Local Planning Panel

31 August 2022

650 Botany Road, Alexandria

D/2022/165

floor space ratio

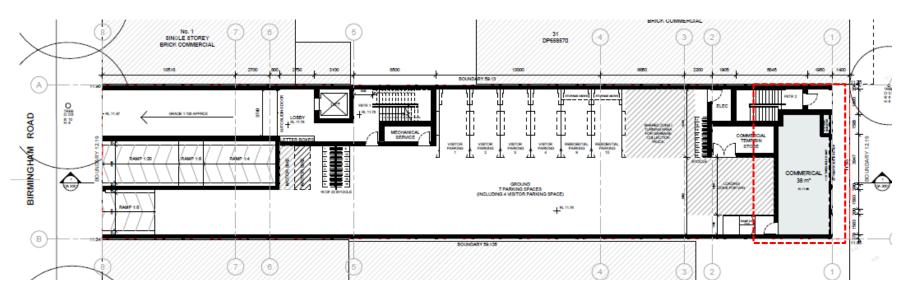
- GFA calculations incorrect do not include waste storage or entrance to residential lobby
- FSR is 2.13:1 = 6.6% variation
- no clause 4.6 request submitted for height or FSR

internal planning and access

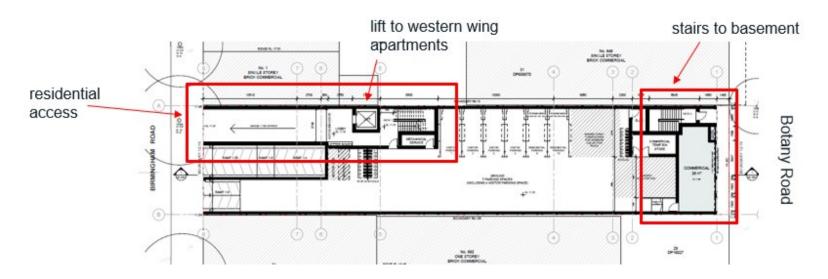
- no access from Botany Road to the ground floor or apartments above
- residential access is via Birmingham Street to a lift

internal planning and access

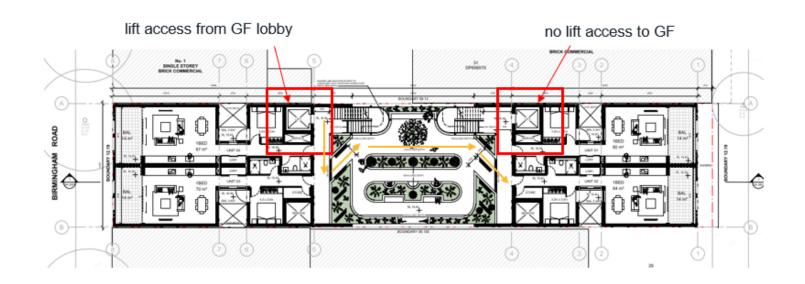
access to Botany Road apartments is via Birmingham Street ground floor lobby, lift to level 1 and through courtyard

street interface

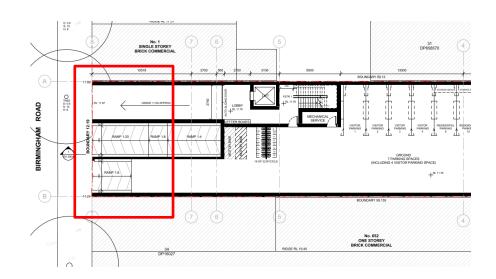
- Botany Road: no residential access
- Birmingham Street dominated by 2 vehicle ramps and poor quality pedestrian entrance corridor

landscape/ open space

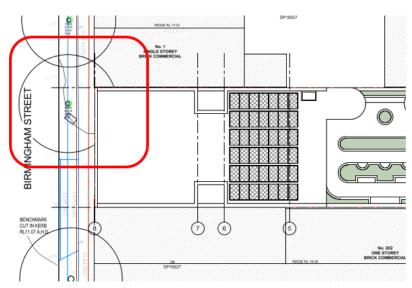
- 160sqm communal open space provided non-compliant
- no deep soil & no trees provided
- does not appear to comply with solar access
- poor amenity located on level 1 with 5 storeys either side, acoustic issues
